Team Update 21

Team Update 20

Figure 4-25 ALLIANCE WALL

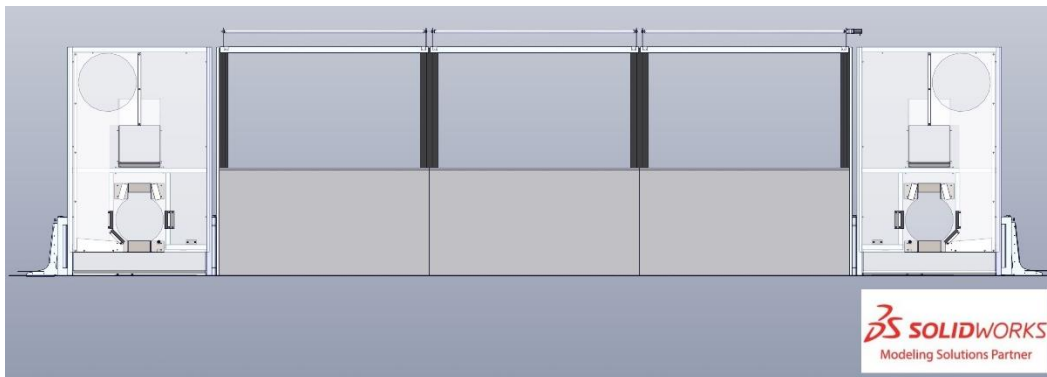
Figure 4-25 has been updated to correct the orientation of the vision target tape on the left side LOADING STATION.

Figure 10-6 BUMPER Vertical Cross Section

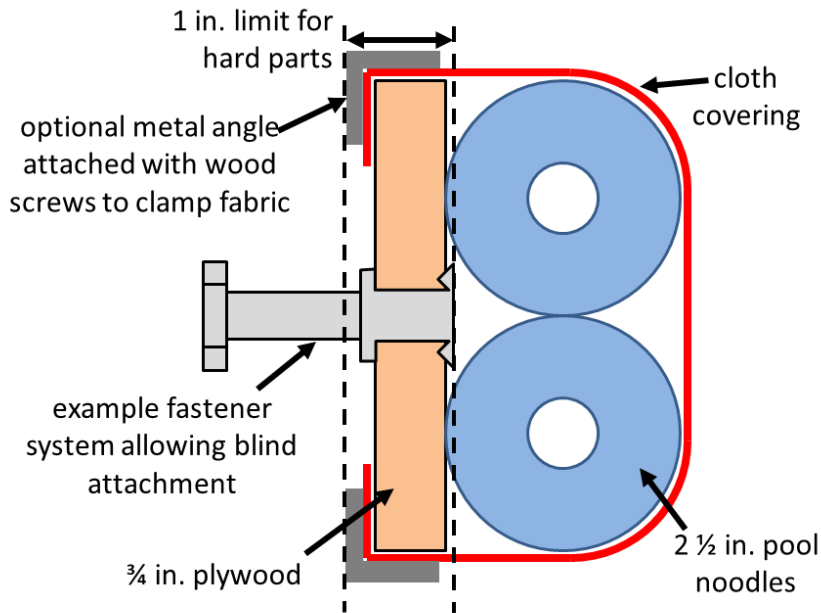
- R31. (Figure 10-6, change is “optional aluminum metal angle attached with wood screws to clamp fabric” in callout)

Figure 10-7 Soft Parts of BUMPER Corners

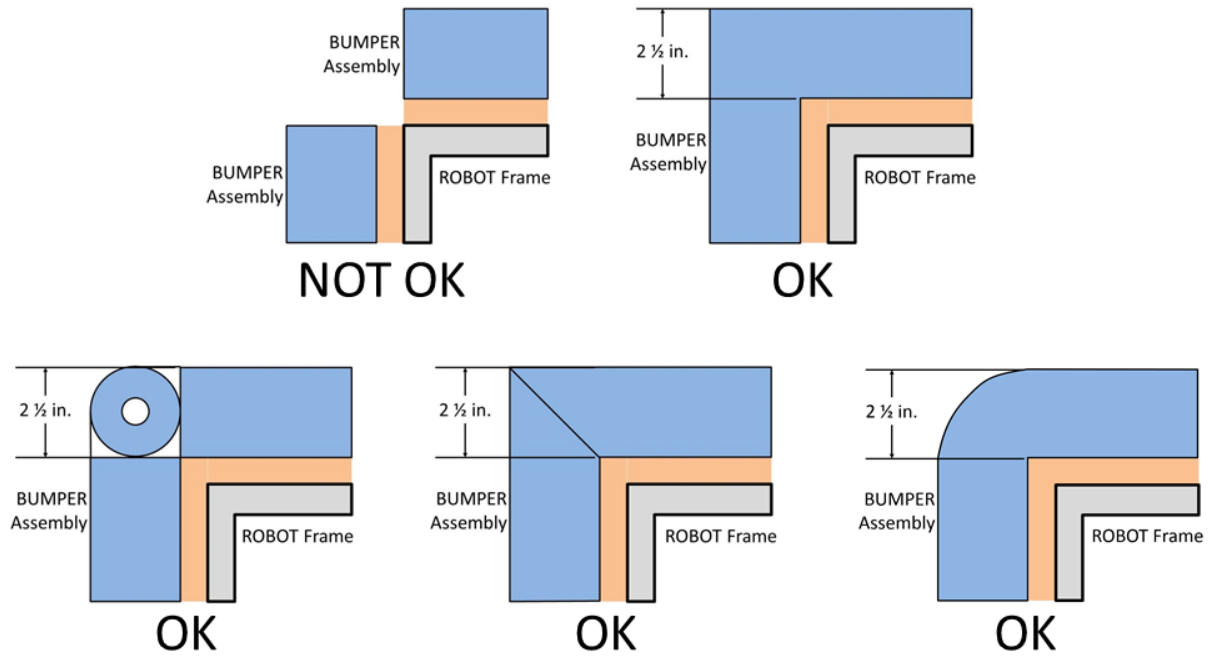
- R32. (Figure 10-7, modified to better represent that the bottom right example is a noodle wrapped around the corner.)

Figure 4-16 Overall CARGO SHIP length and width.

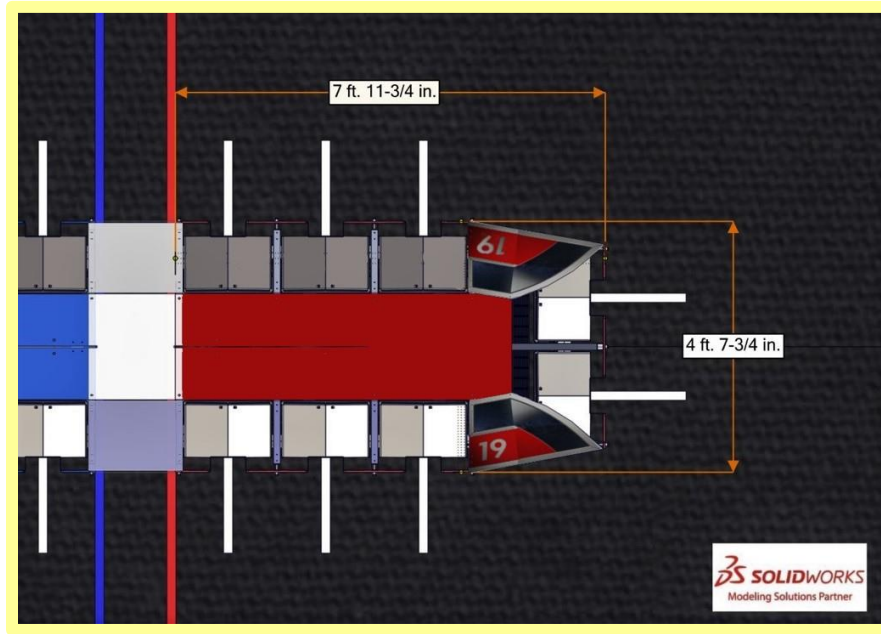
- Figure 4-16 has been added (please note, this addition rennumbers all subsequent images in Section 4).

Figure 4-17 Major CARGO SHIP dimensions.

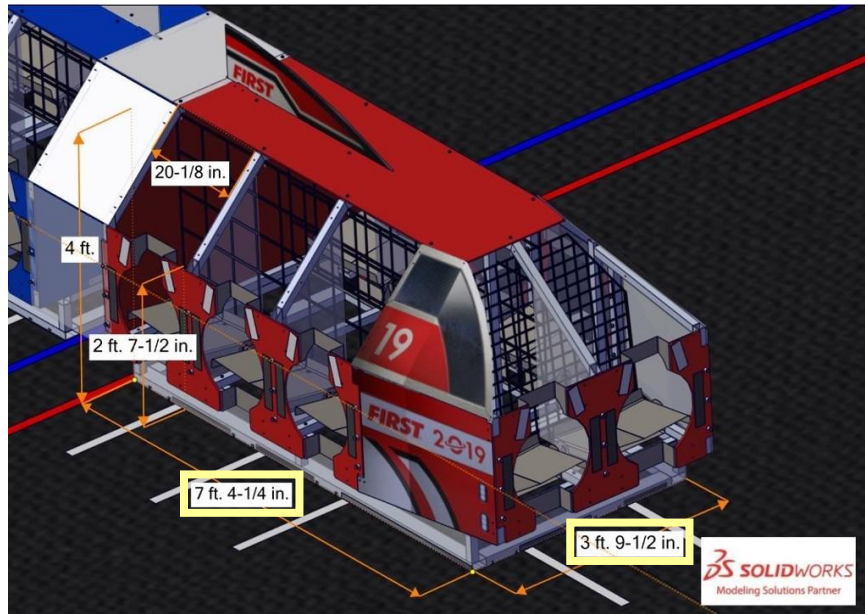
- Figure 4-17 (formerly Figure 4-16) has been updated to correct the length and width of the CARGO SHIP base.

Figure 4-18 CARGO SHIP HATCH geometry and dimensions.

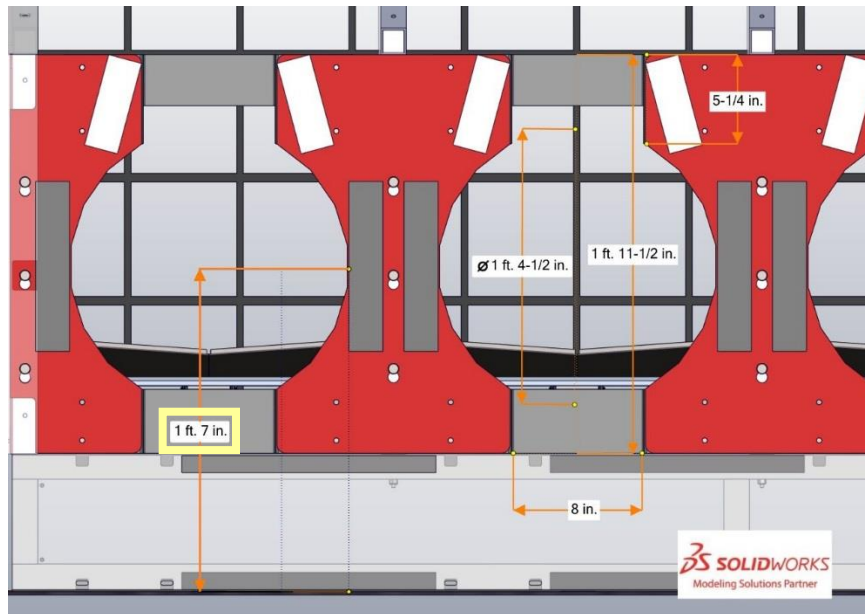
- Figure 4-18 (formerly Figure 4-17) has been updated as follows:

Figure 4-21 Blue HAB PLATFORM with major dimensions.

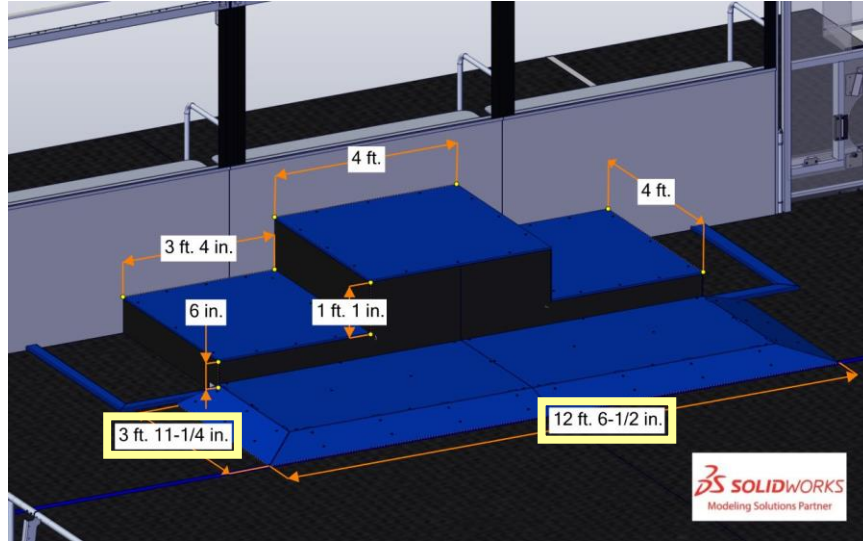
Figure 4-21 (formerly Figure 4-20) has been updated to correct the width and depth of the lowest deck and ramps.

Figure 4-23 Blue DEPOTS

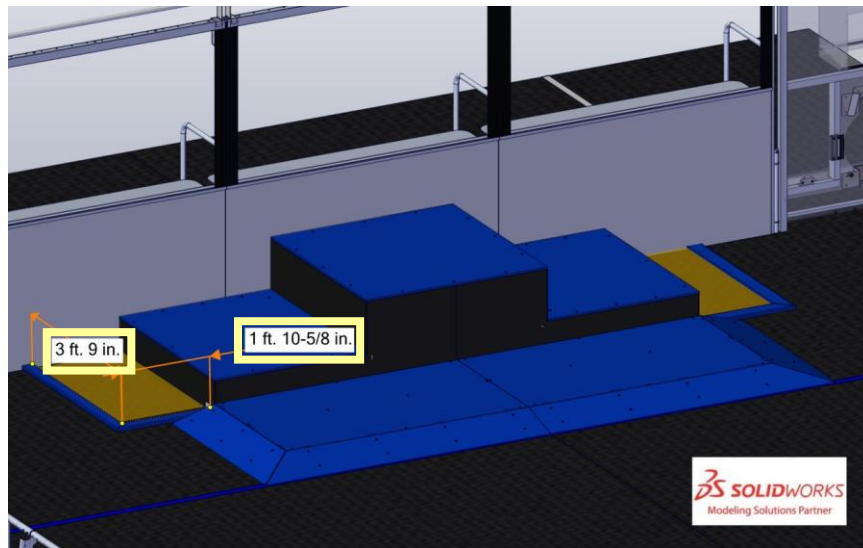
Figure 4-23 (formerly Figure 4-22) has been updated to correct the width and depth of the DEPOT.

Figure 4-28 LOADING STATION

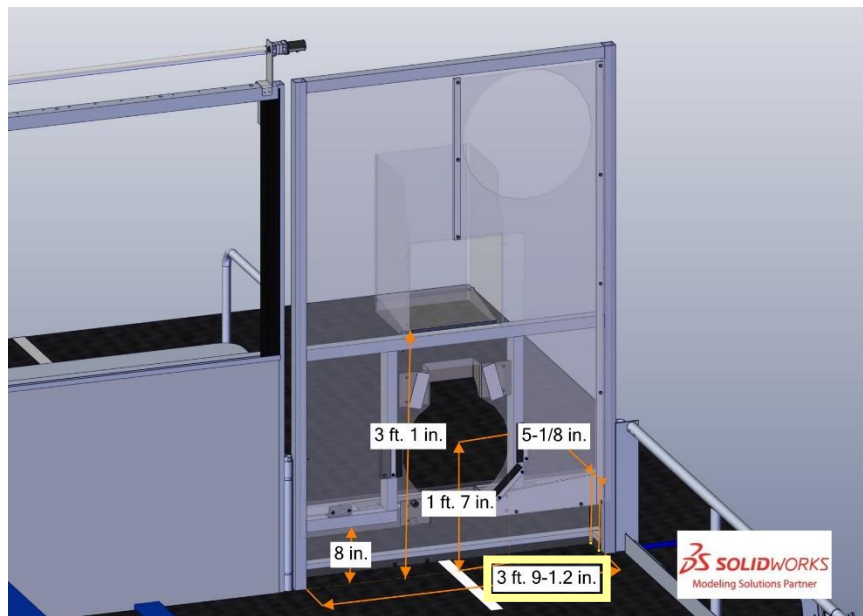
Figure 4-28 (formerly Figure 4-27) has been updated to correct the width of the LOADING STATION.
